STAFF REPORT Architectural Design Review

REVIEW BODY: Planning Commission

**SUBJECT
PROPERTY:** 520-556 North Bayshore Drive, Coos Bay, OR 97420
(25-13-26CA – Tax Lot 1600 & 1700)

SUBJECT: LAND USE APPLICATION – SITE PLAN REVIEW #187-ZON17-086
Change sign panels on an existing pole mounted sign; add wall mounted
signage on the south elevation and add awnings over three entry doors

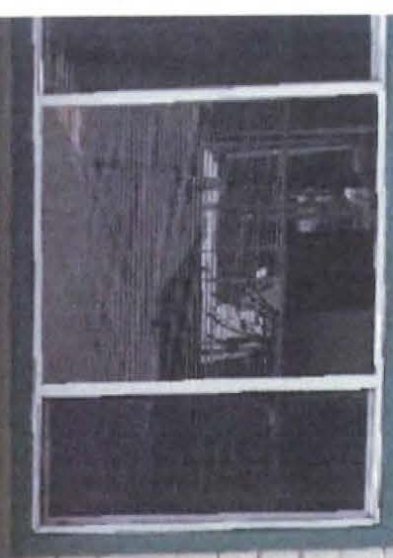
- C4. The proposed change to the sign panels on the existing pole mounted sign is requested due to a company name change. The proposed logo is the standard for the company and while the bright blue, green and yellow is not in the approved color palette for the design district, the colors are consistent with signage colors on adjacent properties as outlined in in "Standard C".

- C5. In order for the design proposal to be approved it must comply with both the architectural design review goals and standards. Colors are regulated in "Standard A" which indicates that bright colors should be reserved for trim or accents unless it is common to the architectural style. However, one or more of the architectural design review standards may be waived as part of the design review process if the applicant can demonstrate the proposal satisfies the architectural design review goals for the design area.

CONCLUSION: The proposed change to the sign panels on the existing pole mounted sign is of an appropriate design and is consistent with signage colors on adjacent properties and the wall mounted signage is sympathetically and does not obscure or remove detailing on the building; Therefore, approval can be supported.

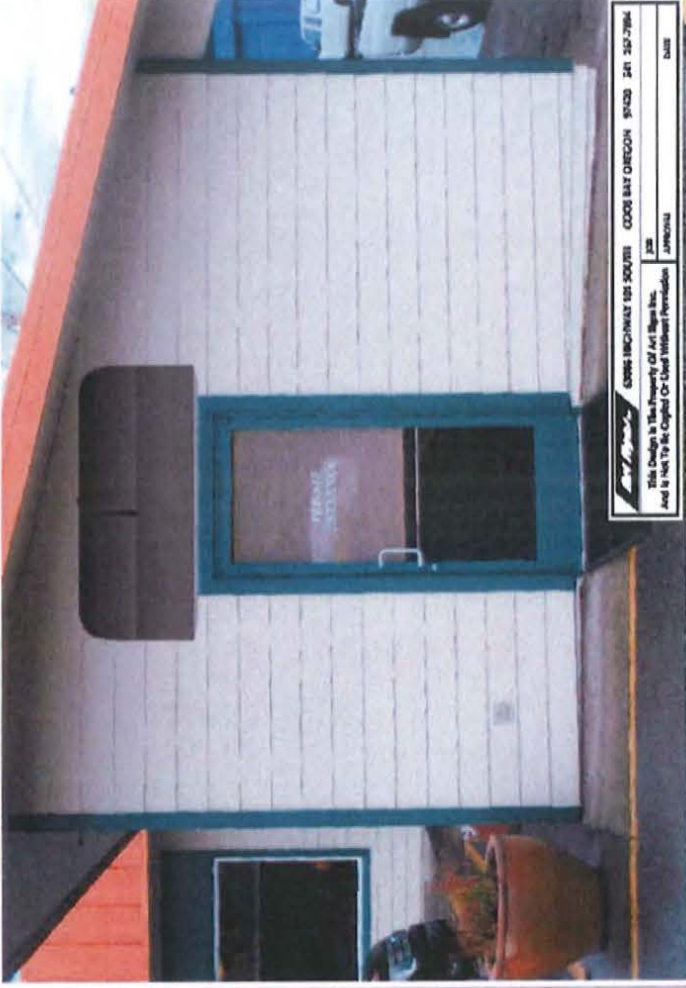
- C5. The proposed wall mounted sign will add "Seaboard Properties" to the existing "Real Estate" signage. The signage will be sited sympathetically on the building and will not obscure or remove detailing on the building. The proposed letter's font style and size appear to be related to the style of the building and general area and will match the font type on the pole mounted sign. The existing wall mounted signage was approved during the Architectural Design Review process of 2004 (Land Use Application #ZON2004-00052).

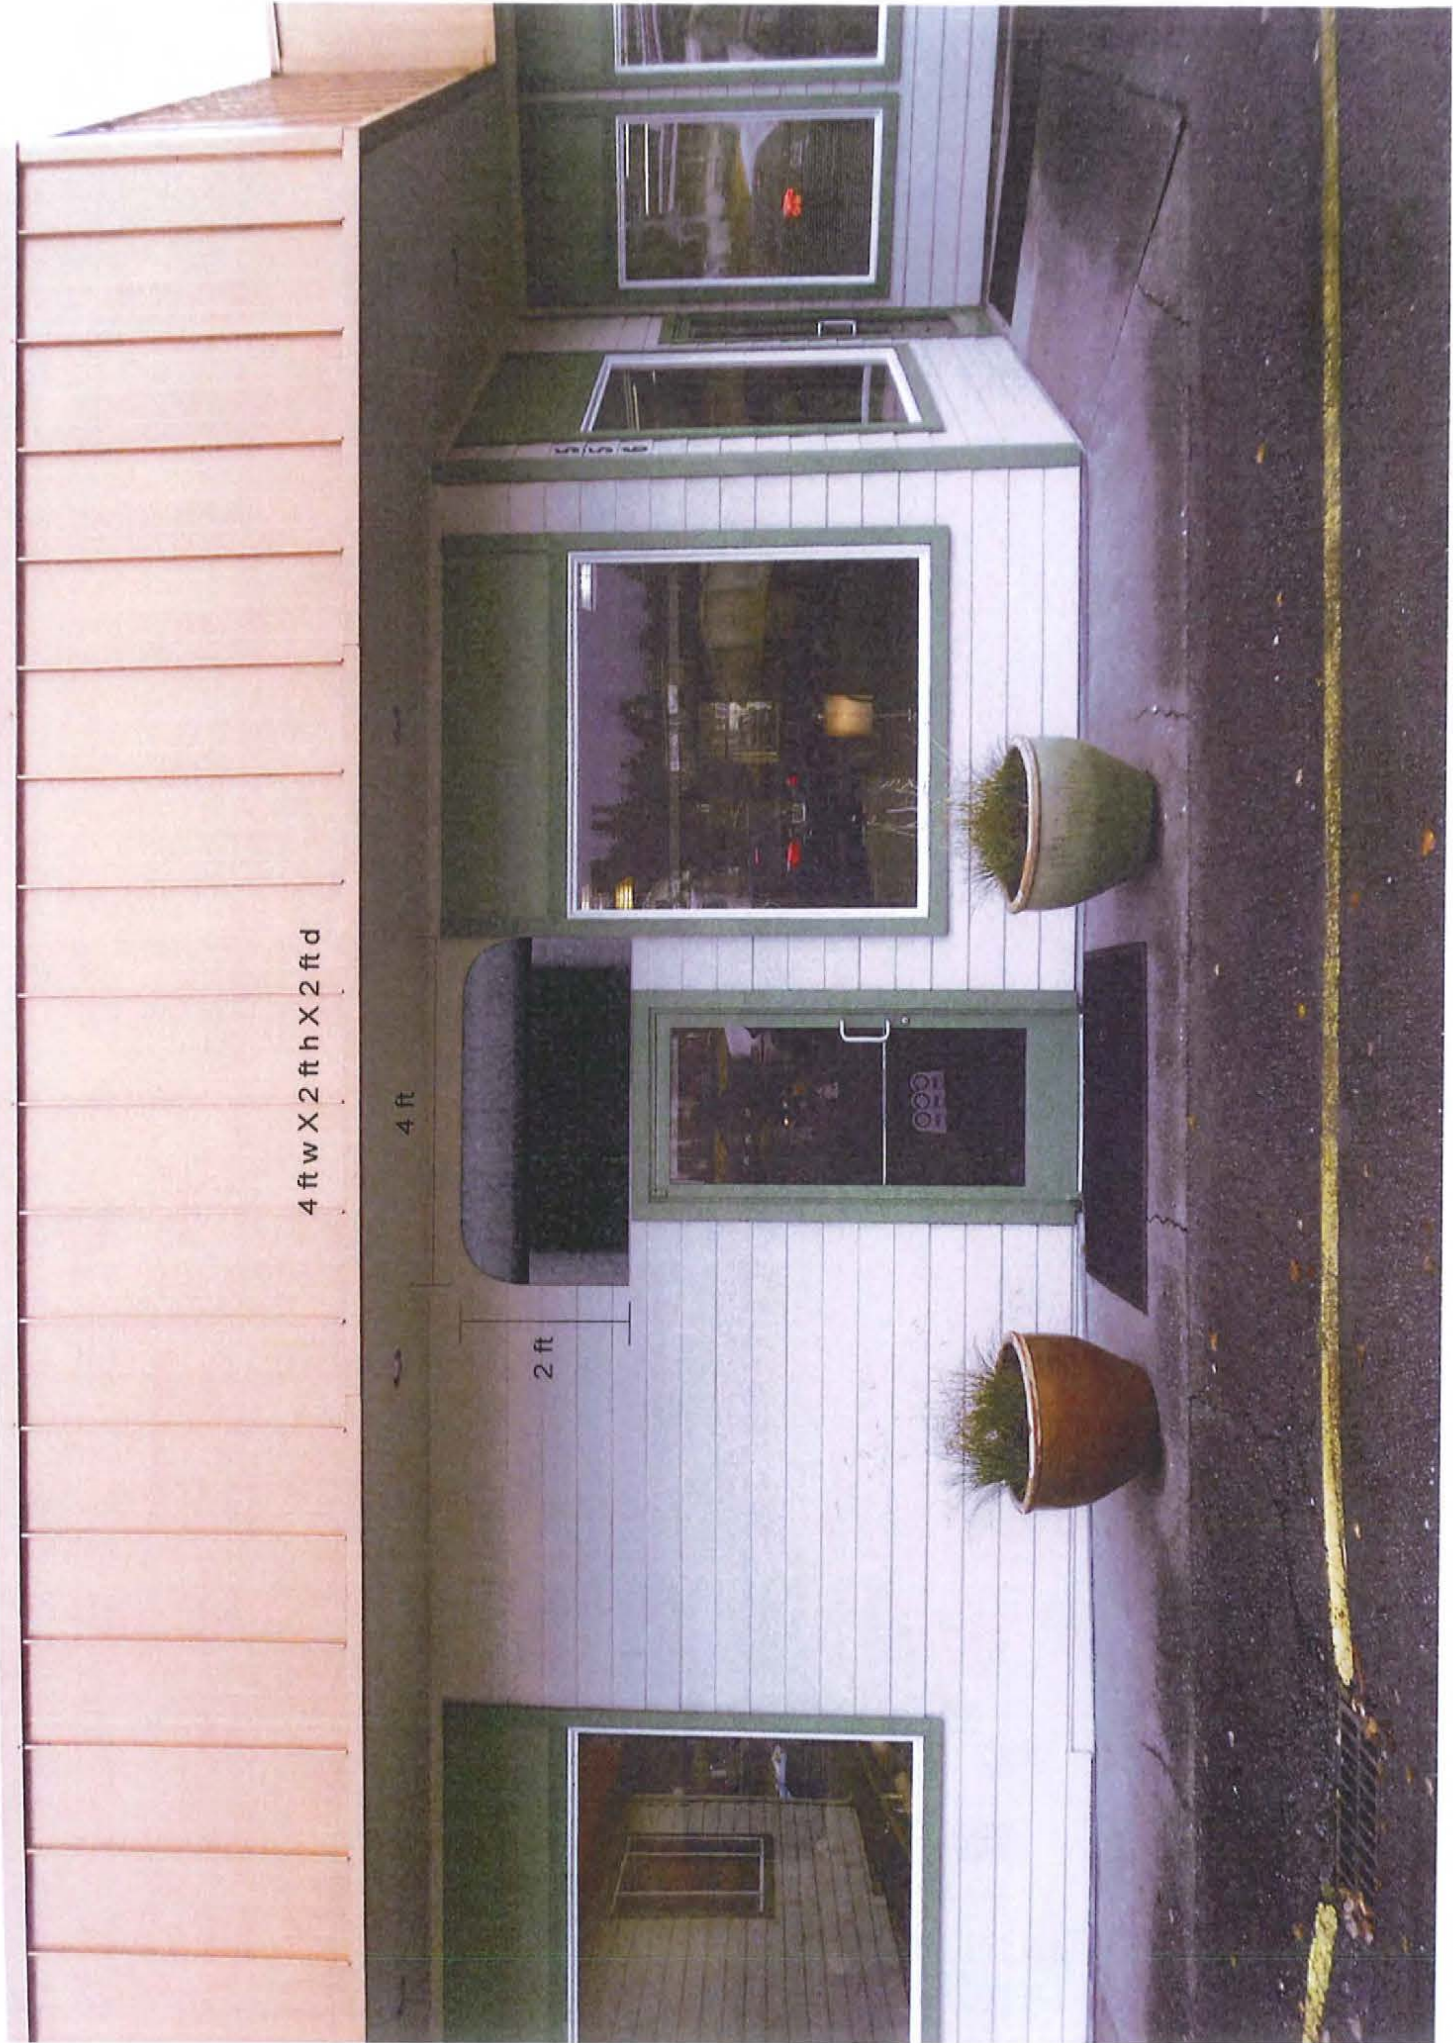
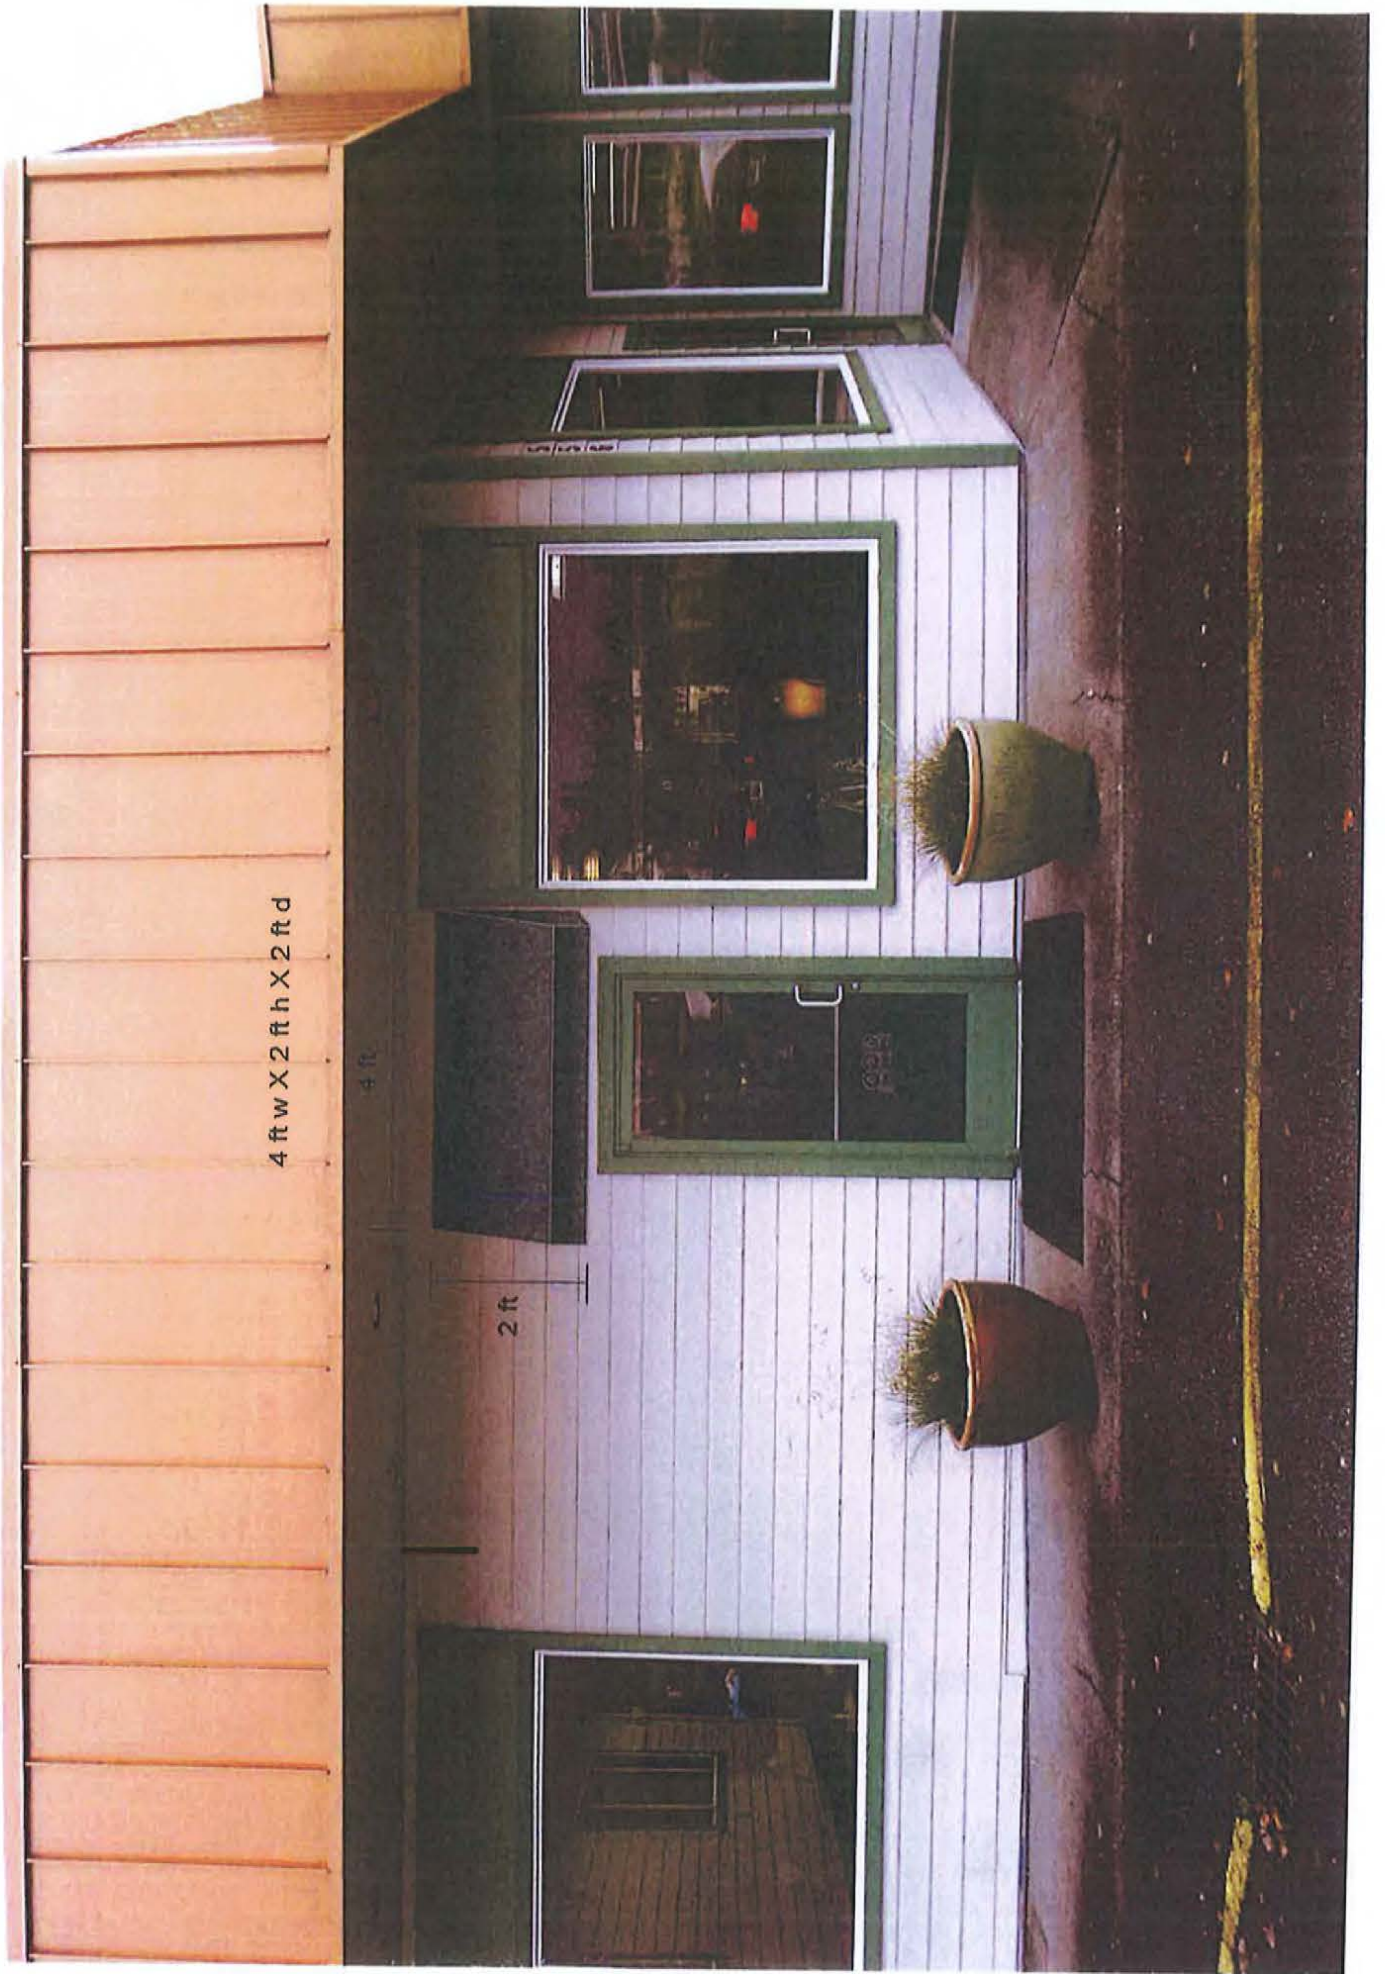
- B3. The Design Assistance Team reviewed the proposed awnings at the Pre-Application meeting held on October 25, 2017. Upon review and discussion, the DAT determined that the proposed awnings were unnecessary given the existing three-foot wide canopy and that they were not in keeping with the designated historic styles or the buildings architectural style. They recommended the awnings not be approved.

- B4. Upon submittal of the complete application, the Design Assistance Team (DAT) reviewed the proposed revised awnings at the meeting held on November 9, 2017. They again recommended the awnings not be approved as they are not necessary and are not in keeping with the designated historic styles or the existing building façade.

- B5. The City received a revised awning design from the applicant via email on November 14, 2017. The revised design was forward to the Design Assistance Team (DAT). They again recommended the awnings not be approved as they are not necessary and are not in keeping with the designated historic styles or the existing building façade.

CONCLUSION: Based on the Design Assistance Team review and determination that the awnings are unnecessary for weather protection because of the existing canopy and that the proposed designs are not in keeping with the designated historic styles or the existing building façade, the review criterion has not been adequately addressed and approval cannot be supported.

FINAL RECOMMENDATION: Based on the statement of facts, findings, conclusions; the Design Assistance Team's Recommendation; and the applicant's submitted evidence, attached hereto and incorporated herein by reference, approve the proposed change to the sign panels on the existing pole mounted sign (without internal illumination) and the proposed wall mounted signage (without internal illumination) of Architectural Design Review application #ZON2017-00068 for 520-556 North Bayshore Drive; and deny the proposed awnings over three entry doors on the bases that they are not in keeping with the designated historic styles or the existing building façade.
